ITEM: 6.4	COMMITTEE OF ADJUSTMENT REPORT SUMMARY MINOR VARIANCE APPLICATION FILE NUMBER A026/23 56 NETHERFORD ROAD, MAPLE
------------------	--

**COMMITTEE OF ADJUSTMENT REPORT
MINOR VARIANCE APPLICATION
A026/23
56 NETHERFORD ROAD, MAPLE**

ITEM NUMBER: 6.4	CITY WARD #: 1
APPLICANT:	Linda Holt
AGENT:	Rebecca Muise, David Small Designs
PROPERTY:	56 Netherford Road, Maple
ZONING DESIGNATION:	See Below
VAUGHAN OFFICIAL PLAN (2010) DESIGNATION:	Vaughan Official Plan 2010 ('VOP 2010'): "Low-Rise Residential"
RELATED DEVELOPMENT APPLICATIONS:	None
PURPOSE OF APPLICATION:	Relief from the Zoning By-law is being requested to permit the construction of a proposed single family dwelling (with attached garage and covered porch), cabana, and swimming pool.

Front & Right-Side Elevations

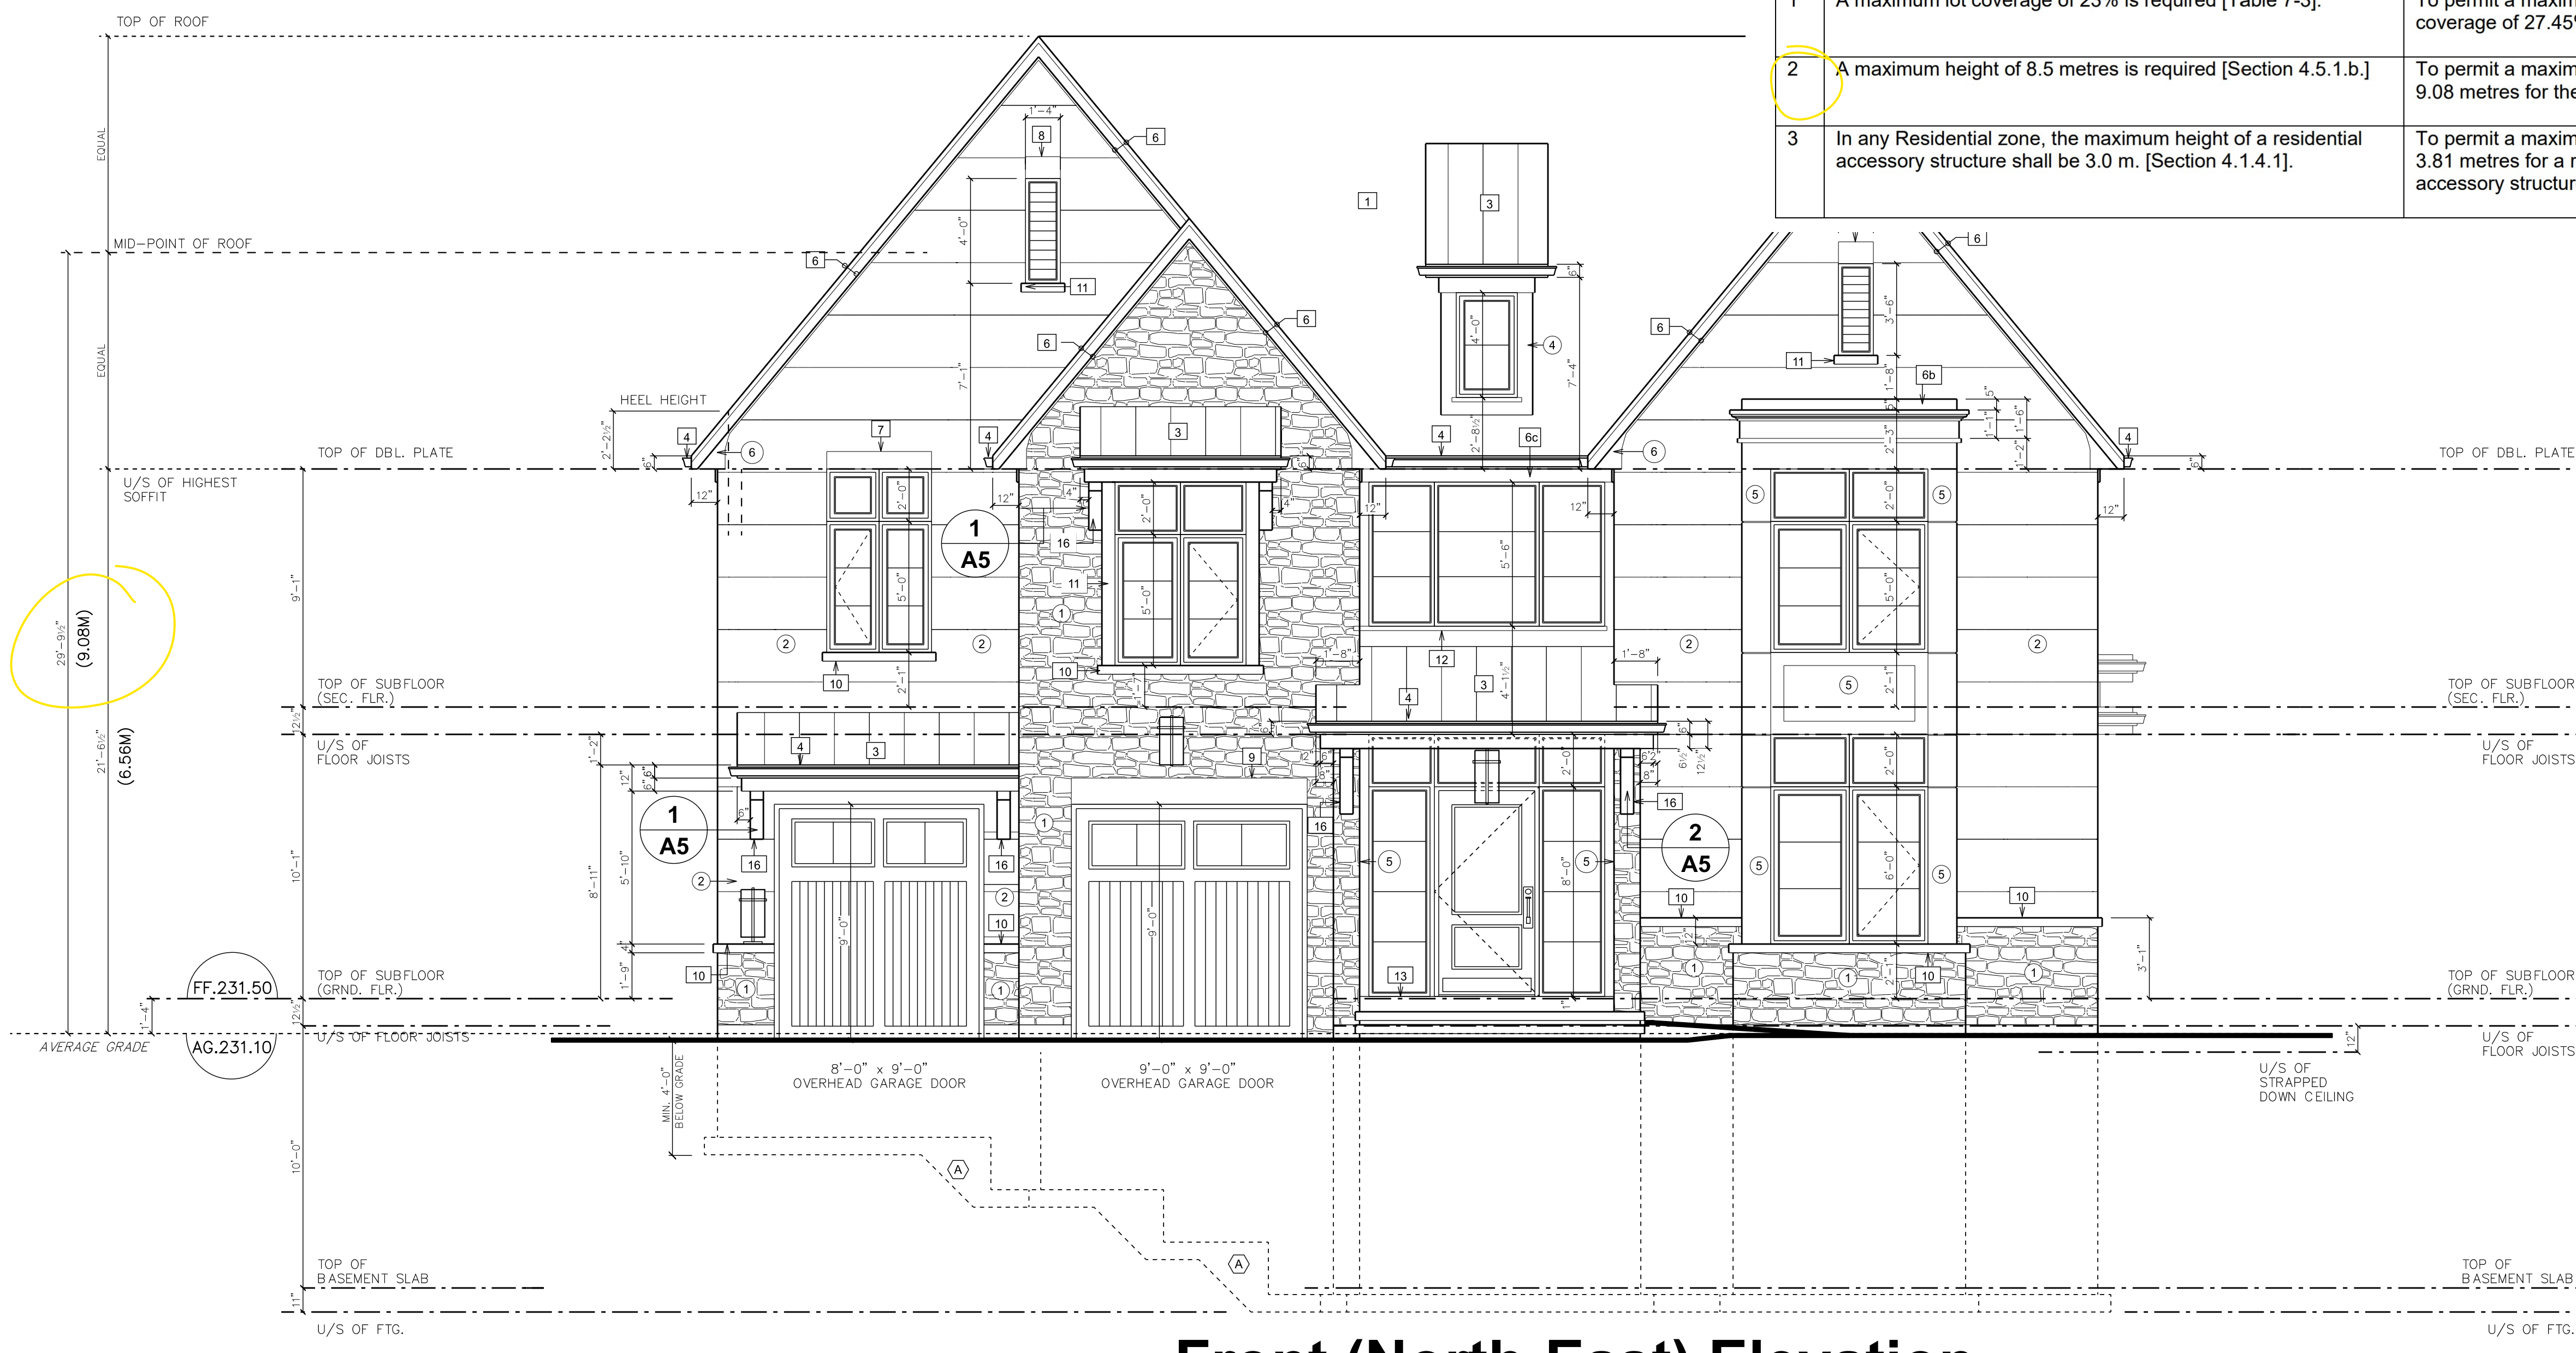
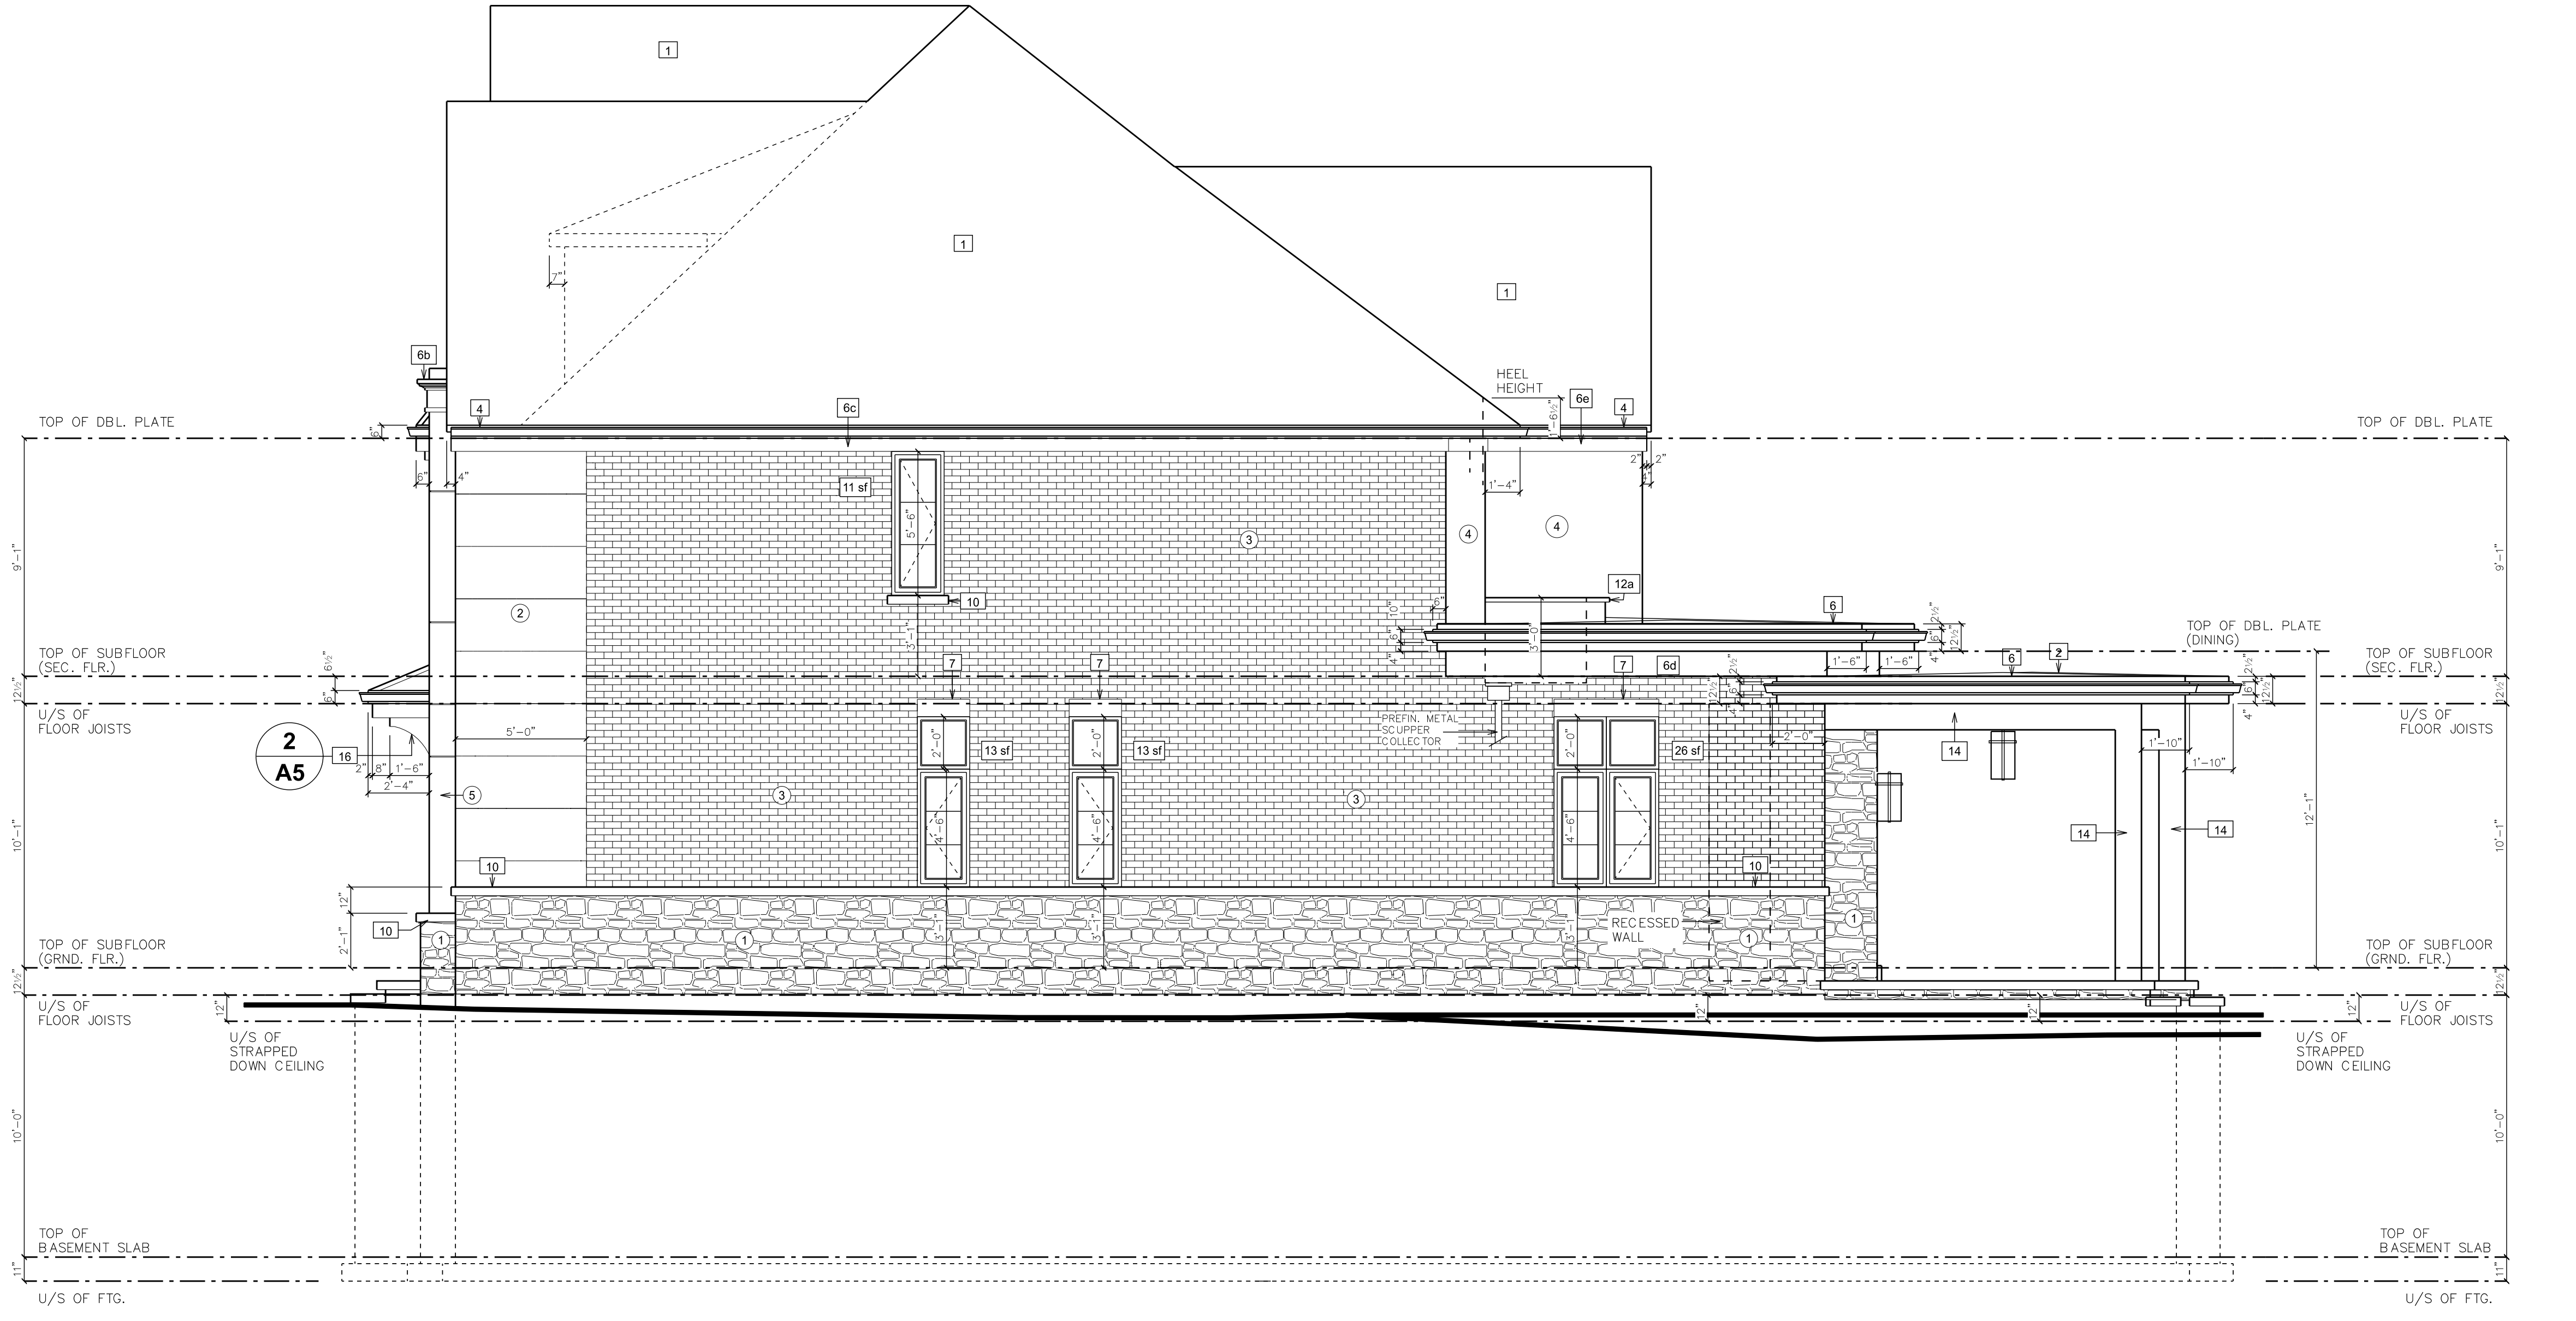
At the request of the Development Planning Department, the Owner has maintained a maximum building height of 9.08 m that is consistent with the existing dwelling on-site (9.81 m) and reduced the maximum lot coverage to 27.45% to ensure the scale of built form remains compatible with other new development in the immediate neighbourhood. The proposed two-storey dwelling (with garage) occupies 20.74%, while the remaining 6.71% is associated with the proposed front/rear porch and cabana. Planning staff have no objection to Variances 1 and 2, as it facilitates a development that preserves the character of the neighbourhood. With respect to Variance 3, the increase in maximum height for the residential accessory structure (cabana) is reasonable given its spacious setbacks and surrounding vegetation that helps mitigate any massing implications. It should also be noted the height relief only applies to the centre gable; the two ends, which have flat roofs, comply with the By-law.
